# **Land East of Junction 11 of the M40, Banbury**

## *Transport Assessment Addendum*

26<sup>th</sup> October 2022  
SJT/RT/23457-06f Transport Assessment Addendum

- 1.5 It is within this context that a Transport Assessment (TA) was prepared which supported a planning application for this development. Oxfordshire County Council (OCC) have commented on this application (ref: 22/01488/OUT) which can be seen in **Appendix B**. This includes a list of transport improvements.

JOB TITLE		LAND AT M40 J11		CLIENT		GREYSTOKE	
DRAWING TITLE							
A361 ROUNDABOUT WITH SECONDARY ACCESS							
SCALE	DRAWN BY	DATE	DRAWING No	REVISION			
1:1000@A1	RM	04/10/22	23459-06-01-GA	A

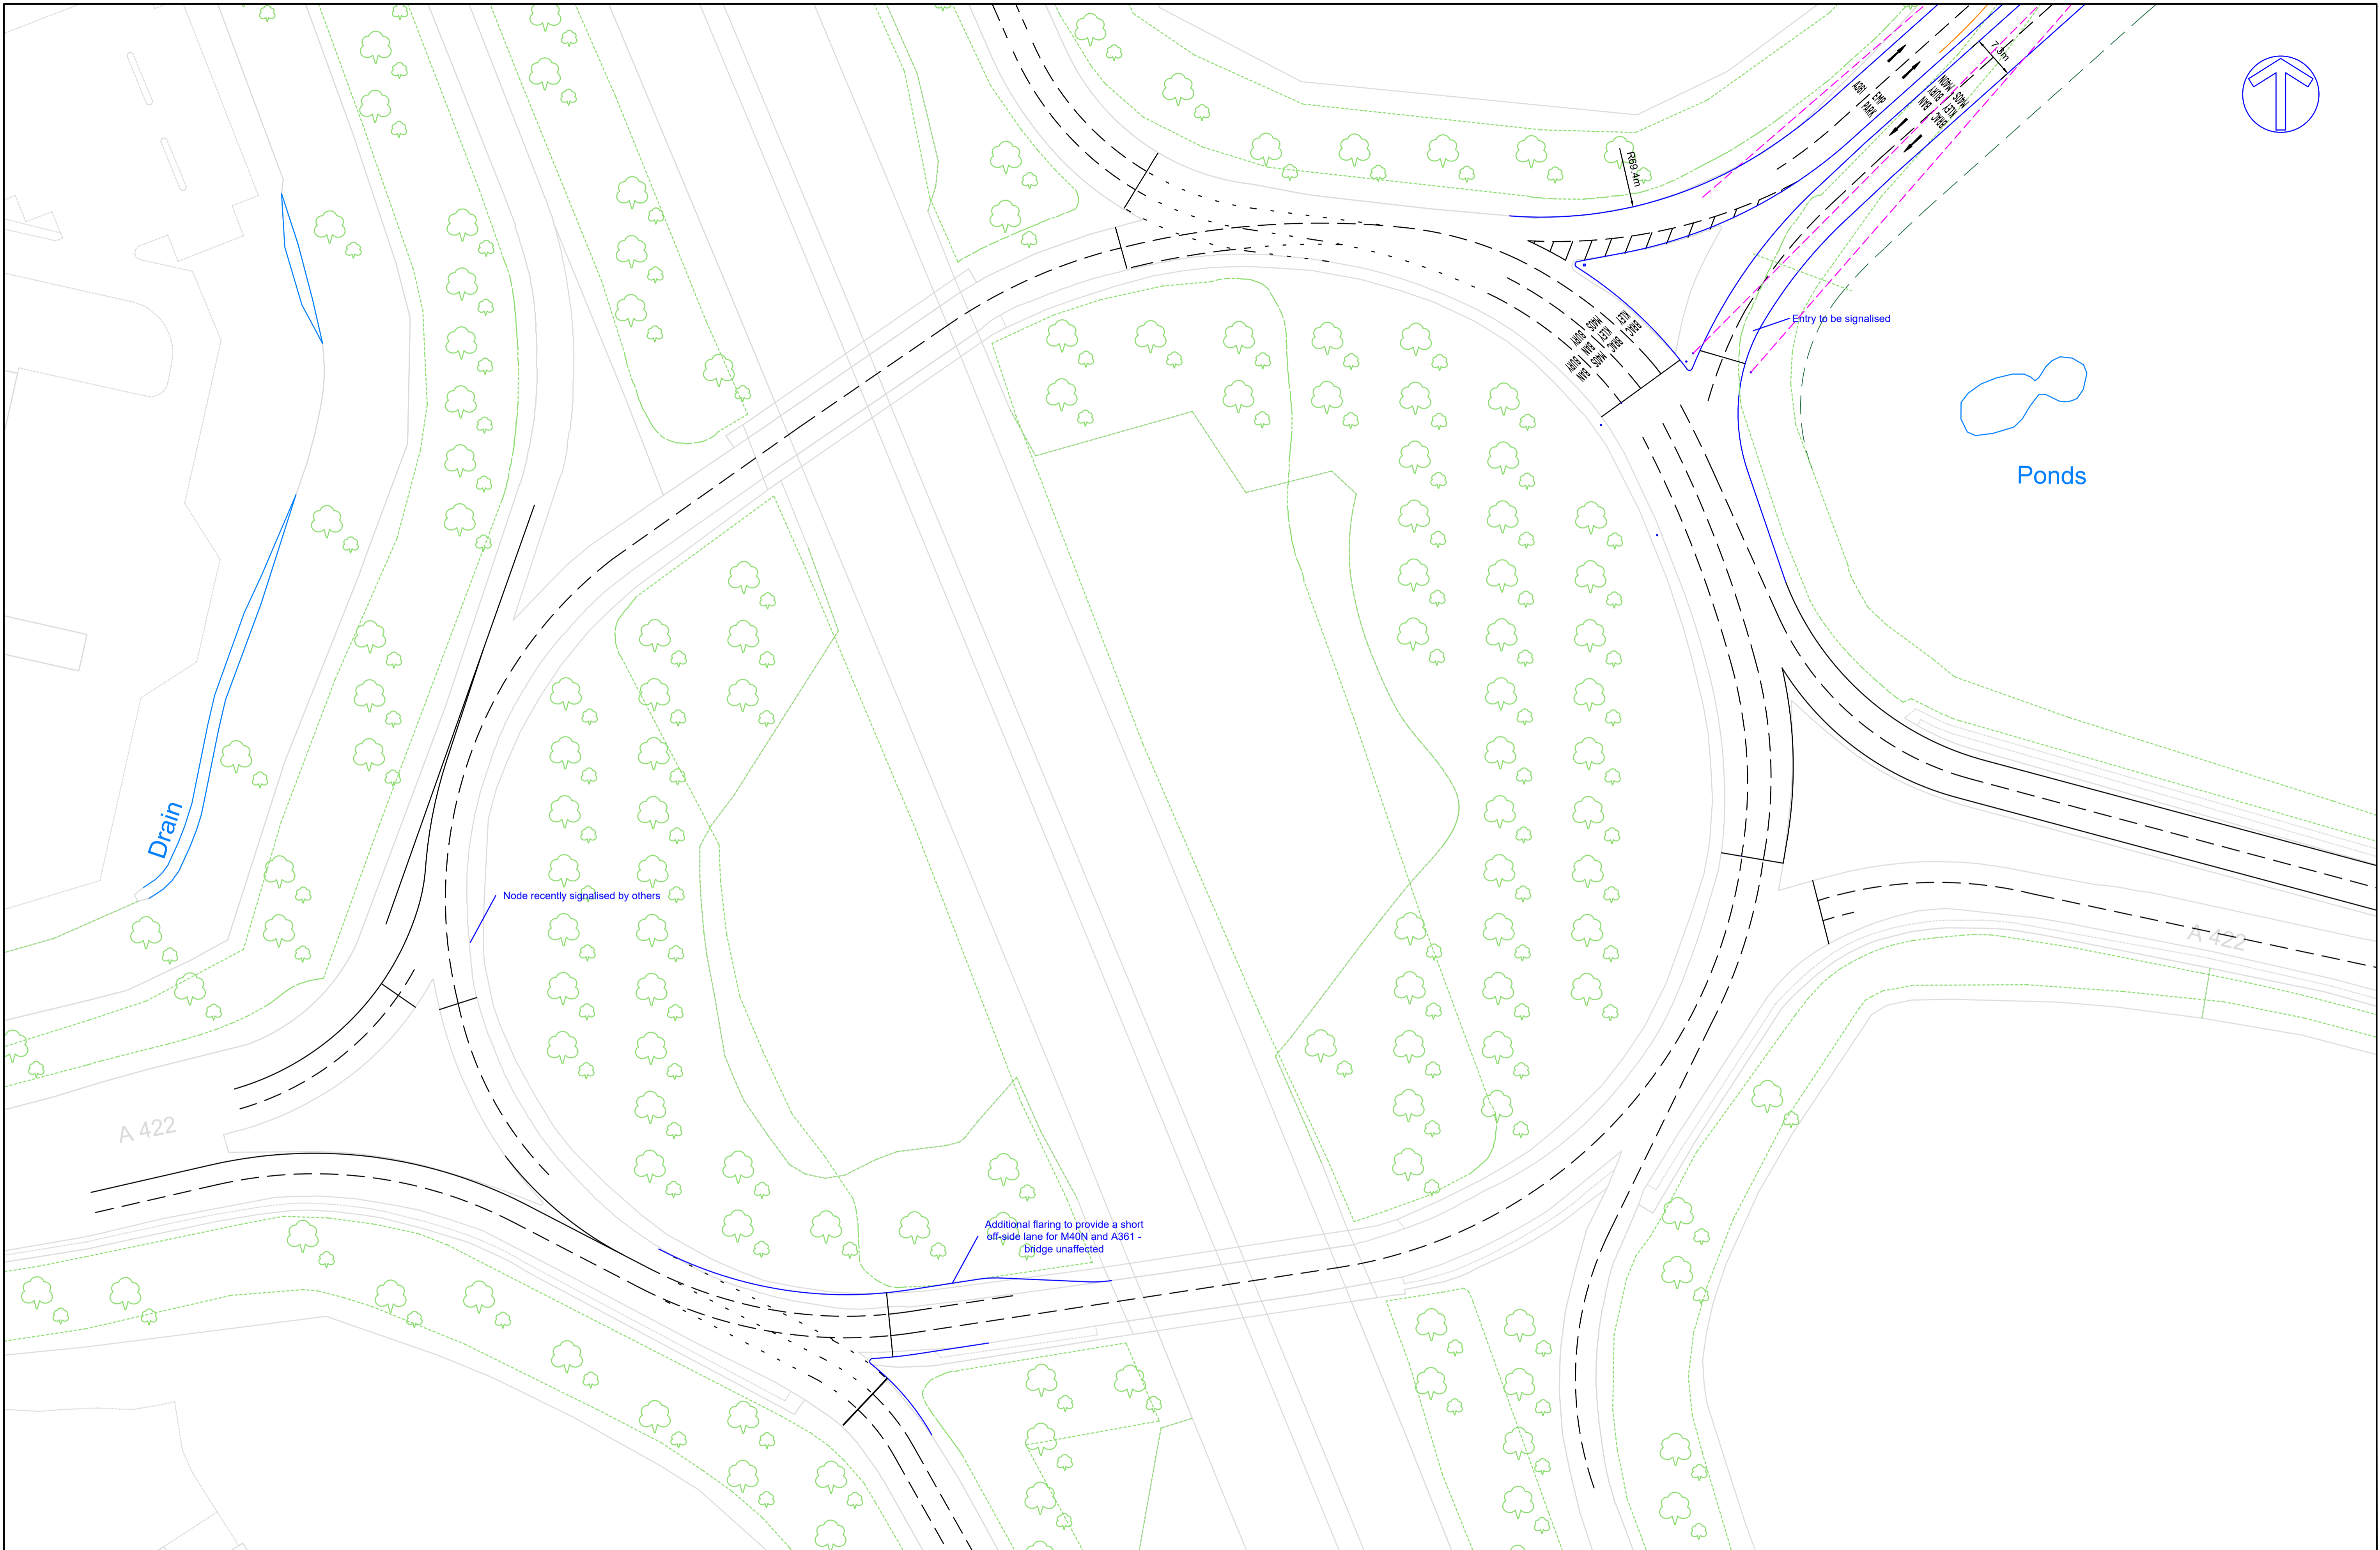
*DMRB GG 119 recommends that a Stage 1 Road Safety Audit should be undertaken before planning consent is applied for, but this has not been included. Given the scale of the development and the changes required to the highway layout, a Stage 1 RSA would have been informative.*

- 4.5 A Stage 1 Road Safety Audit will be carried out once the VISSIM modelling has been undertaken and any access changes resulting from the outputs have been altered to allow the modelling to show that the proposed development does not show any significant impact on the network.
